# **Armadillo-800 EVA Revision Information**

**A8000-D00Z**

**Version 1.1.0  
2012/02/28**

**Atmark Techno, Inc.**

Figure 3.1. HDMI CEC Signal Line Peripheral Circuit

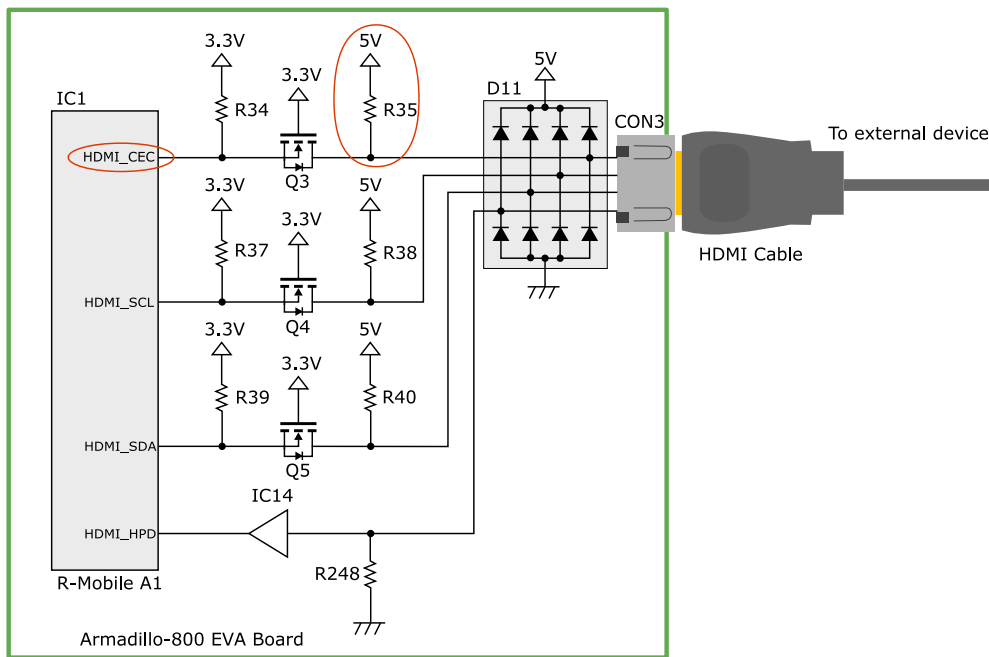
The HDMI CEC signal line is pulled up by 5V when it should be pulled up by 3.3V.

Because of this, a voltage (5V) over that specified in the HDMI standard is applied to the CEC line of external devices (display monitors etc) connected by the HDMI cable, which could in the worst case cause damage to the external device.

Remove the part below so that the over-voltage is not applied.

- R35

Because there is a possibility that external devices which use CEC may malfunction, it is recommended to remove the parts below.

- Q3
- D11

This erratum was fixed in product revision B as shown below.

- R35, Q3 and D11 are not mounted.
